## Issue List

### SPCC Aseptic Training Facility (Monroe, NC)

#### Project Issue Information

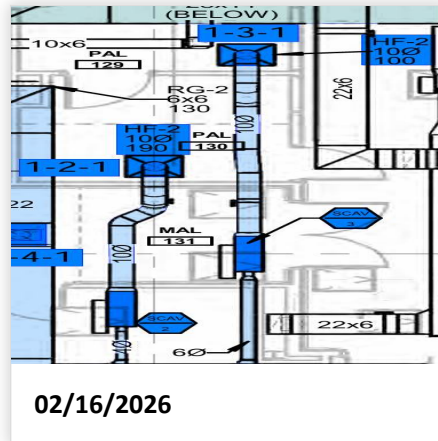
**Issue Name :** FCU-4 Not Installed  
**Description :** FCU-4 is not installed.  
**Created By :** National TAB                      **Assigned To :** National TAB - Antonio Flores-De La Cruz  
**Status :** Open  
**Priority :** Urgent                                      **Asset Tag :**  
**Originated Date :** 02/17/2026 - Antonio Flores-De La Cruz - National TAB

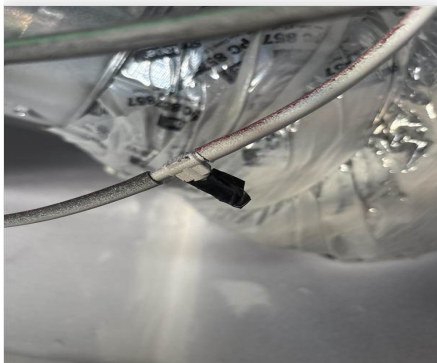
**Issue Name :** SCAV-2 Missing Cap  
**Description :** SCAV-2 is missing the cap on the T fitting for one of the pressure tubes.  
**Created By :** National TAB                      **Assigned To :** National TAB - Antonio Flores-De La Cruz  
**Status :** Open  
**Priority :** Urgent                                      **Asset Tag :**  
**Originated Date :** 02/17/2026 - Antonio Flores-De La Cruz - National TAB

- **02/17/2026 National TAB - Antonio Flores-De La Cruz**
  - FSS was made aware of the issue and was going to replace the cap. Unsure if it was done.
